REPORT TO APPLICATION DETERMINATION PANEL

20 B Marinella Street Manly Vale - Modification of Development Consent DA2012/0564 granted for Construction of a dwelling house

APPLICATION FOR MODIFICATION ASSESSMENT REPORT

Application Number:	Mod2015/0088
Responsible Officer:	Charise Chumroonridhi
Land to be developed (Address):	Lot 24 DP 1195888 , 20 B Marinella Street MANLY VALE NSW 2093
Proposed Development:	Modification of Development Consent DA2012/0564 granted for Construction of a dwelling house
Zoning:	LEP - Land zoned R2 Low Density Residential
Development Permissible:	Yes
Existing Use Rights:	No
Consent Authority:	Warringah Council
Land and Environment Court Action:	No
Owner:	Onk Operations Pty Limited Caroline Jane Weightman Revell Weightman
Applicant:	Tomasy Pty Ltd

LANDSCAPE PLAN

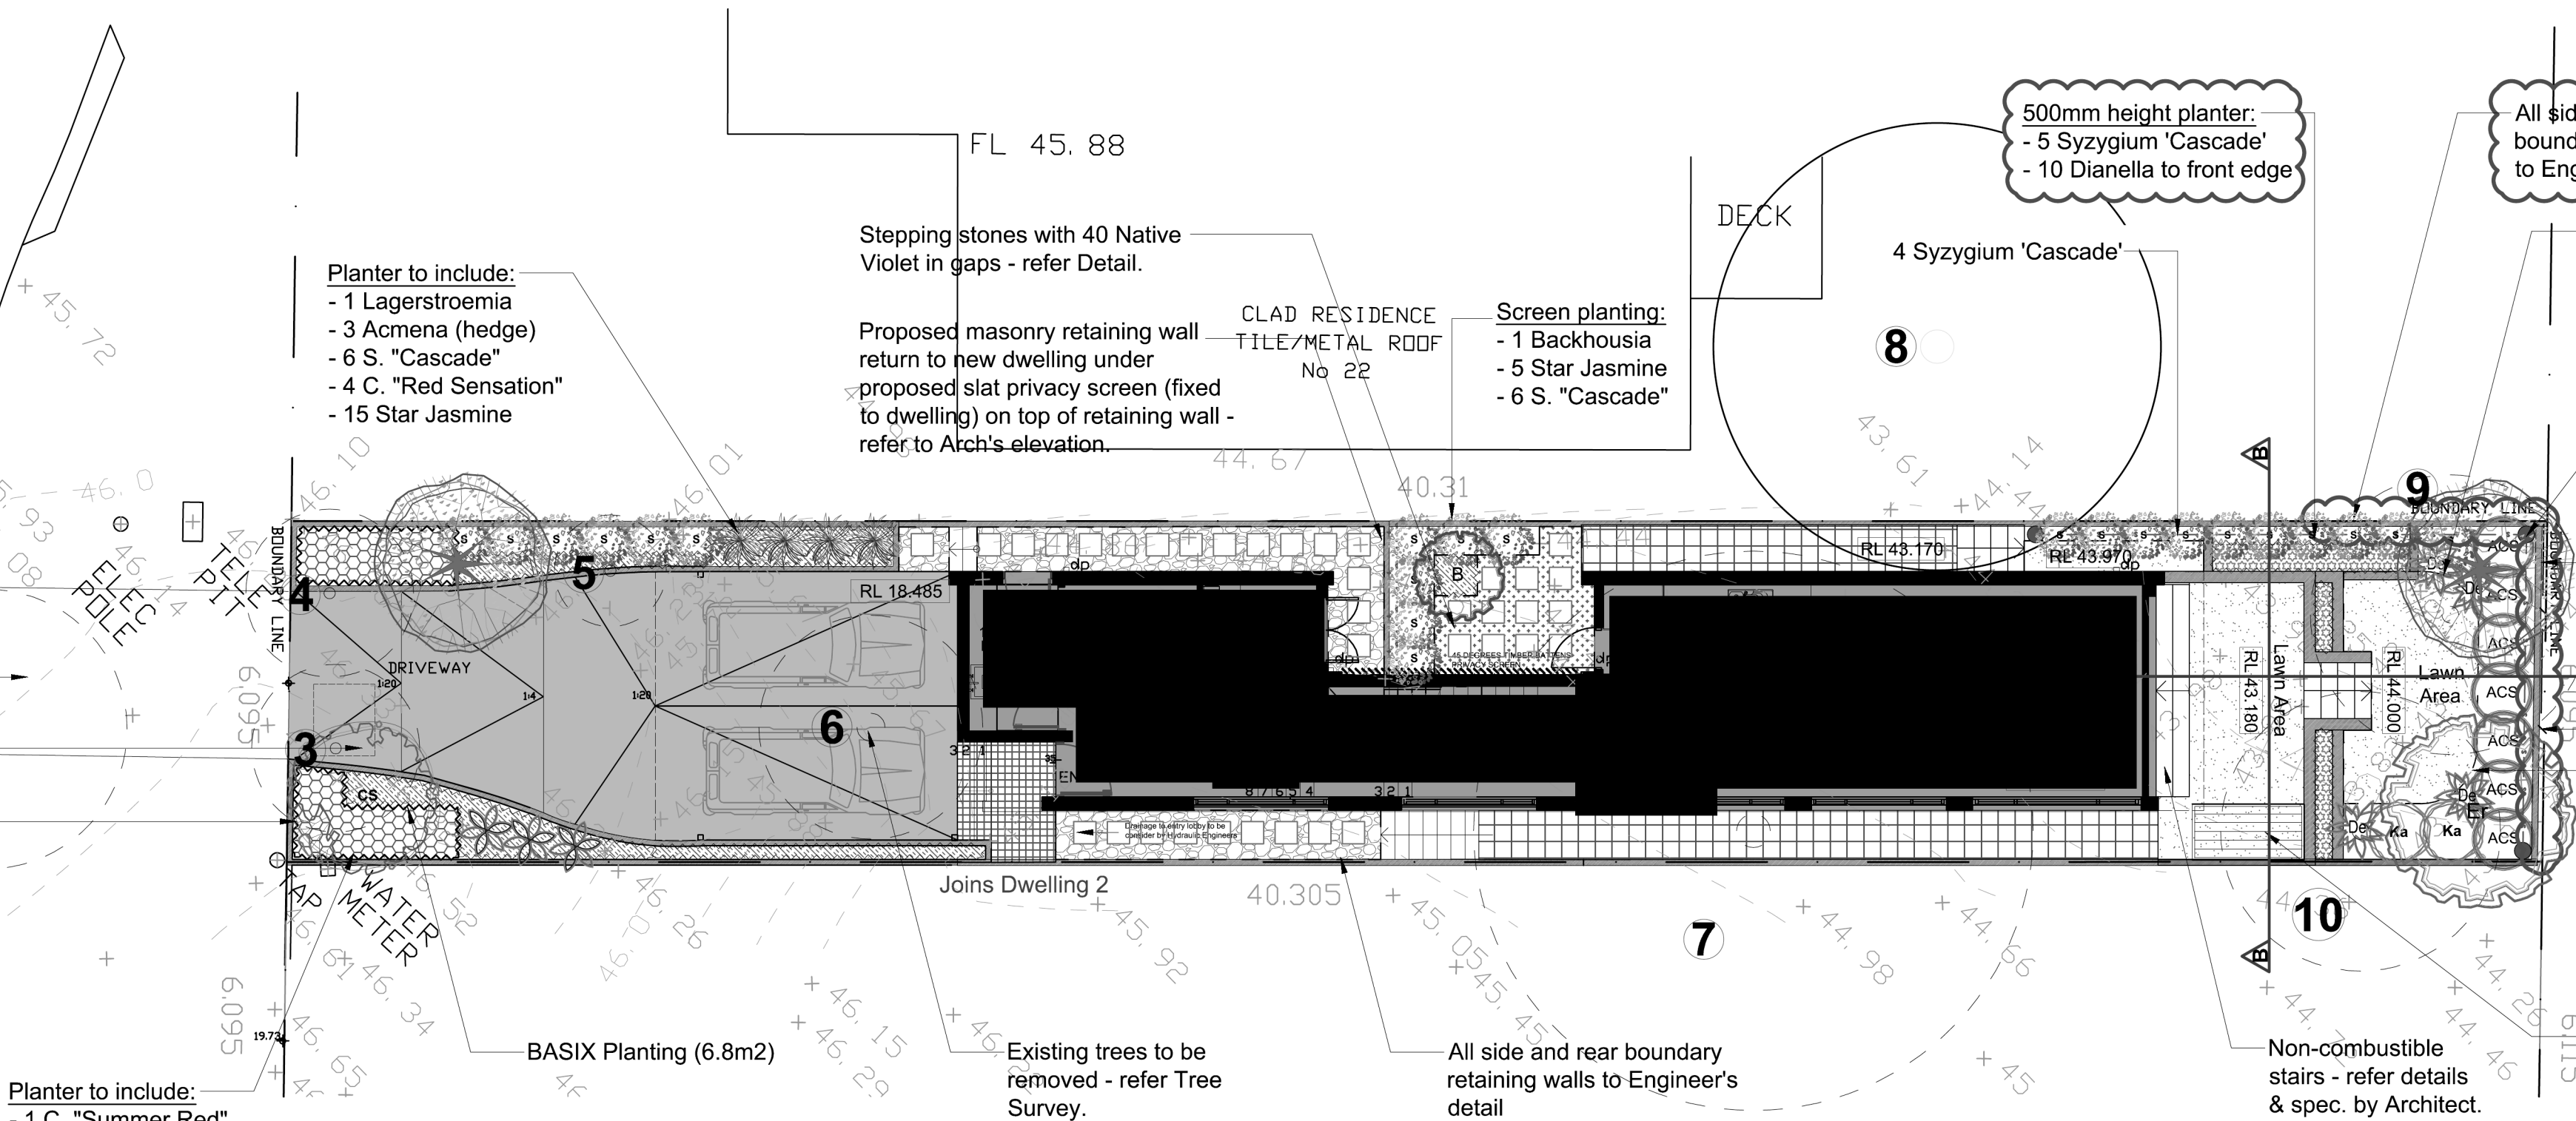
Comment: Amended plans were provided on 3 July 2015 with a timber fence no higher than 1.8 metres from the ground level of No. 22 Marinella Street and an open pool style fence 1.2 metres above the ground level of subject site. In addition, landscaping has been provided along the southern and western boundaries to minimise overlooking into the private open space of No. 22 Marinella Street. A condition has also been included in the consent to ensure the raised area along the southern boundary is to be maintained as a planter box to ensure privacy is protected.

The landscaping within the planter boxes adjoining the southern boundary is to be retained and maintained in perpetuity.

SOUTHERN ELEVATION: REAR YARD LANDSCAPE

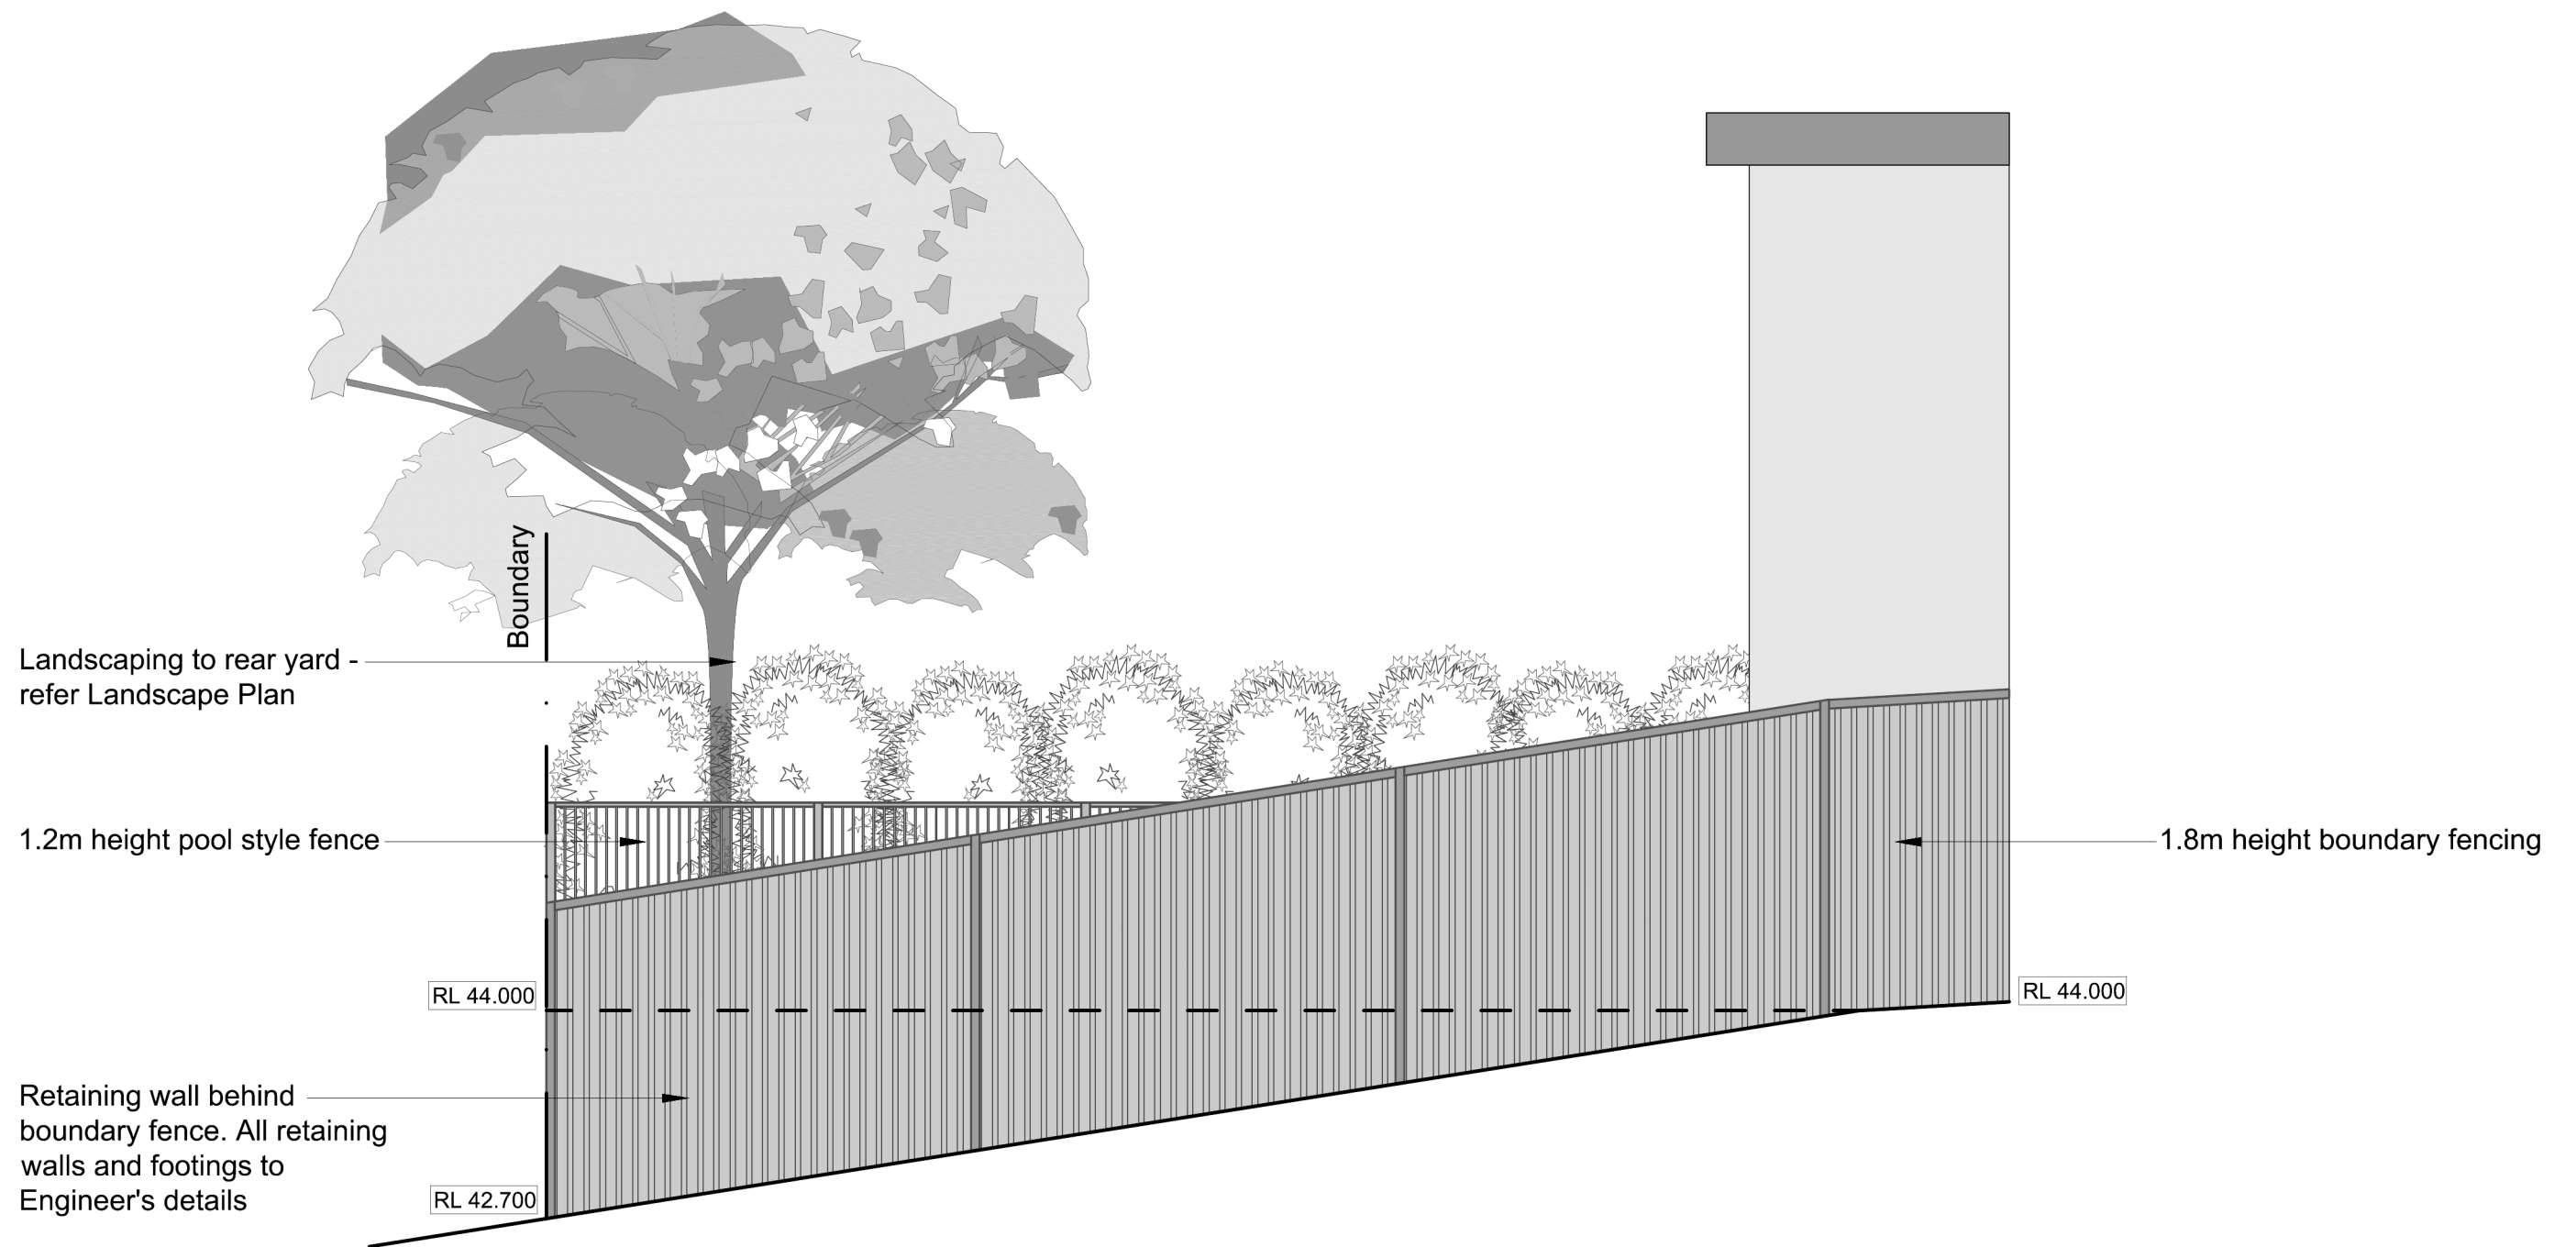
The modifications consist of a retaining wall and open style pool fence with a nil setback to the southern boundary. The retaining wall will reach a maximum height of 1.3m when measured from the ground level of the adjoining property to the south. The pool fence will be 1.2m in height and will sit on top of the retaining wall.

The retaining wall and the majority of the pool fence will be hidden behind a 1.8m boundary fence. The elements of the pool fence that will protrude above the boundary fence will be of an open style and will have landscape planting behind it.

The proposed development raises the ground level in the rear yard along the southern boundary which may cause privacy impacts for the adjoining property at No. 22 Marinella Street. Amended plans were provided on 3 July 2015 and 31 July 2015 involving new screen planting that will mature to a height of 1.5m - 6m along the southern and western boundaries.

A planter box will also be required to be constructed along the southern boundary to ensure that area is non-trafficable and is maintained as a dense, planted garden bed.

WESTERN ELEVATION: REAR YARD LANDSCAPE

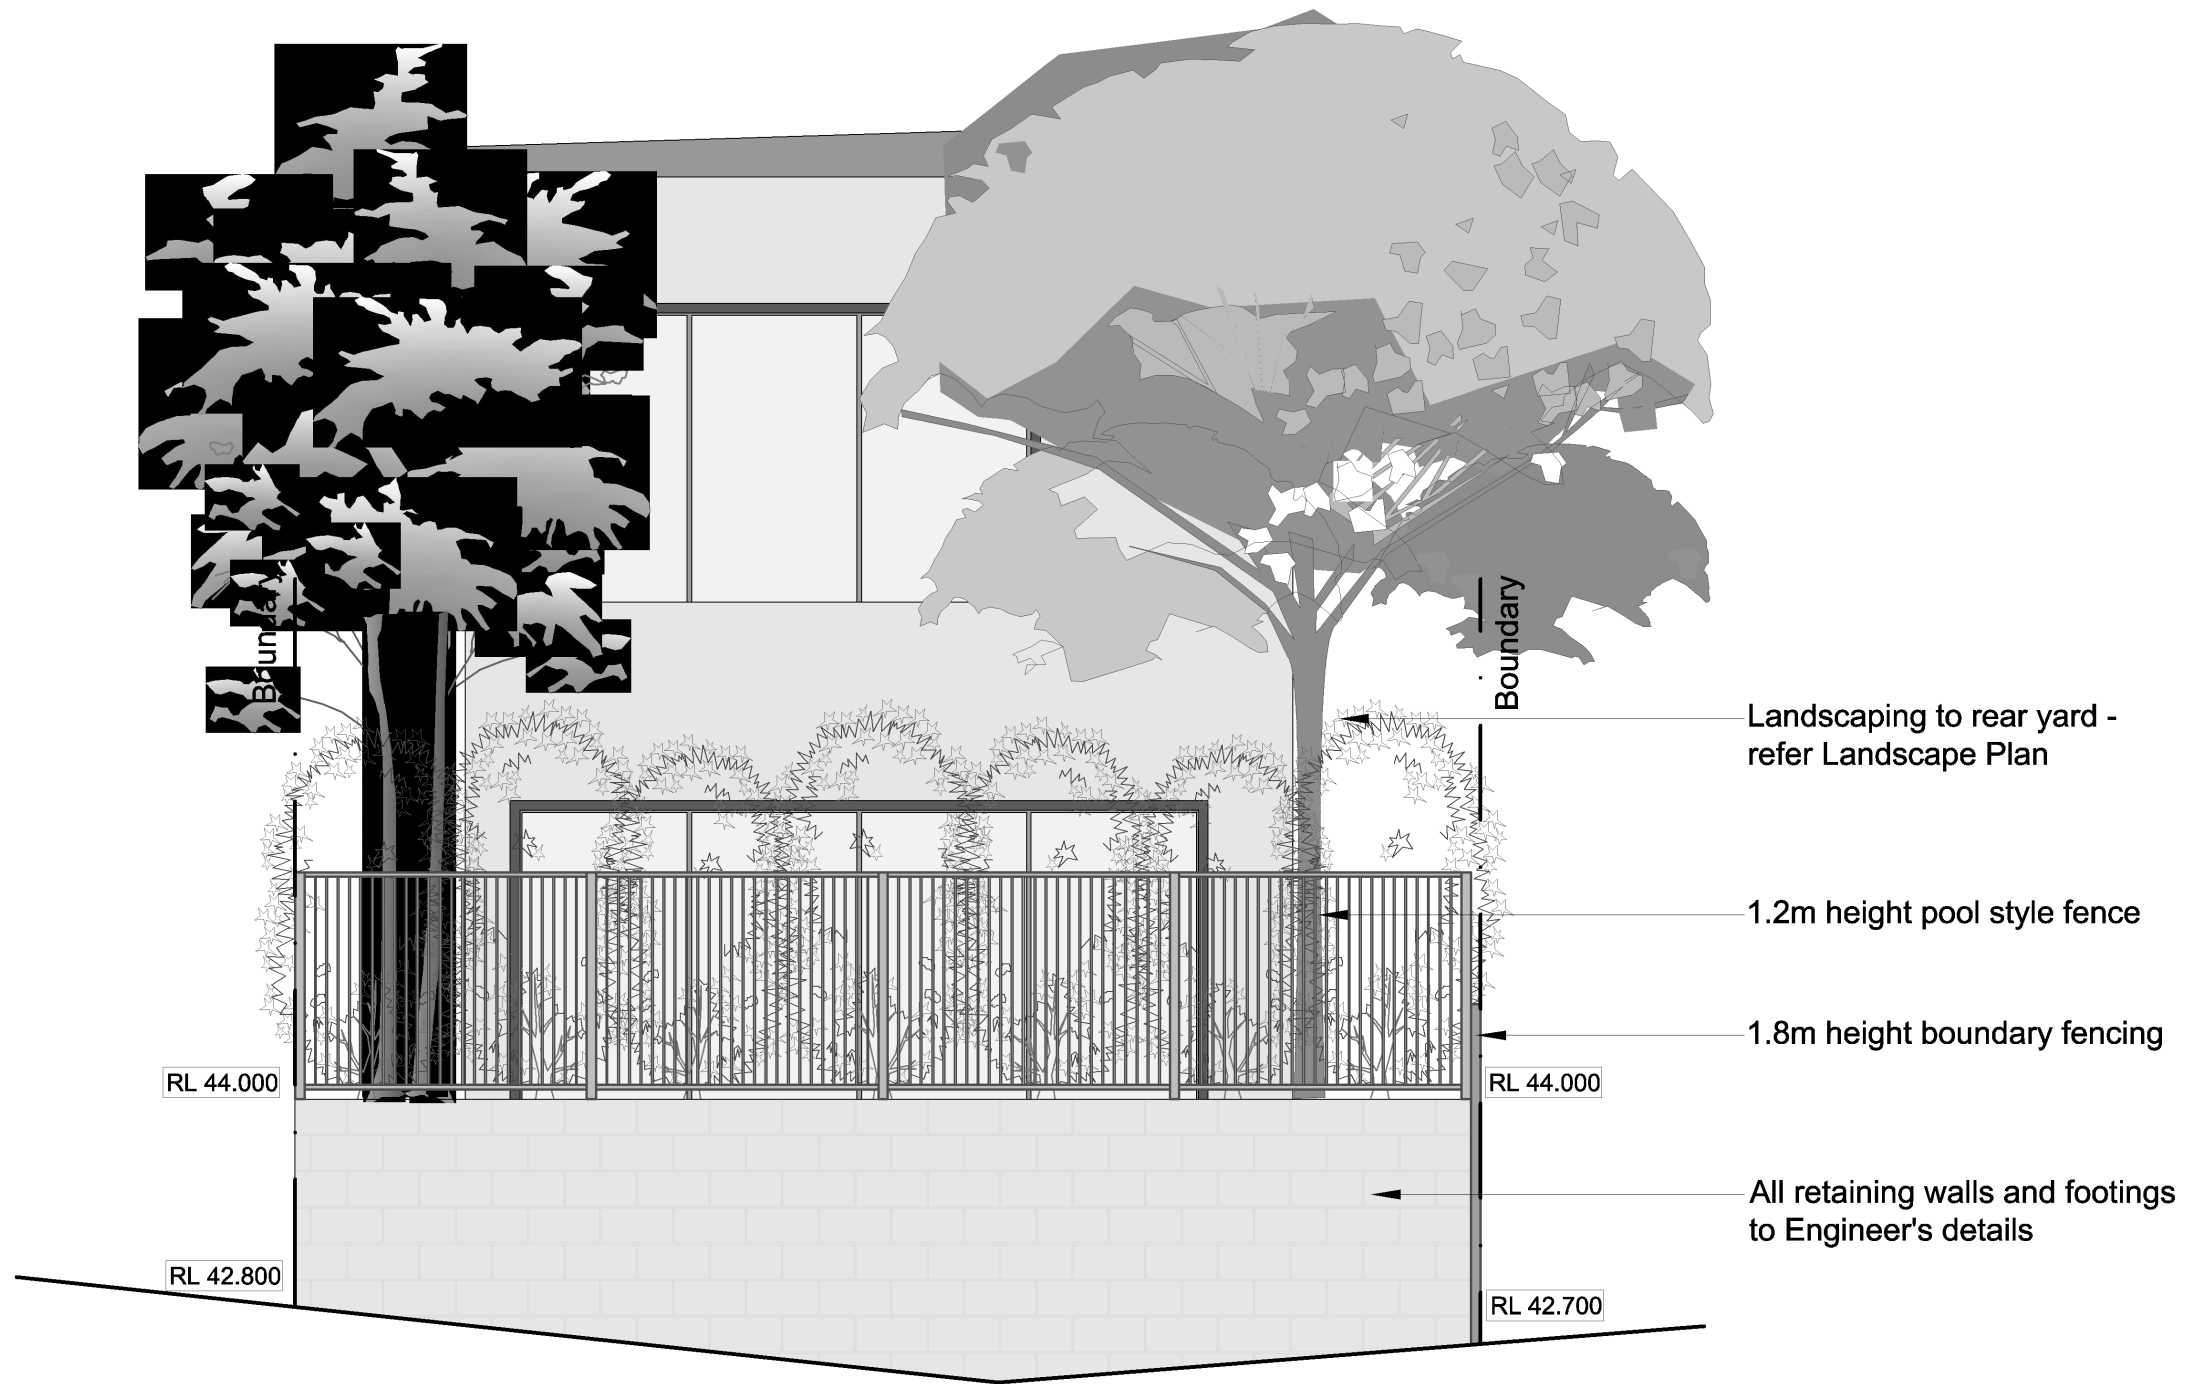
The modifications along the rear boundary consist of a retaining wall and open style pool fence with a nil setback. The retaining wall will reach a maximum height of 1.5m when measured from the ground level of the adjoining public reserve. The pool fence will be 1.2m in height and will sit on top of the retaining wall. The pool fence will be of an open style and

will have landscape planting behind it.
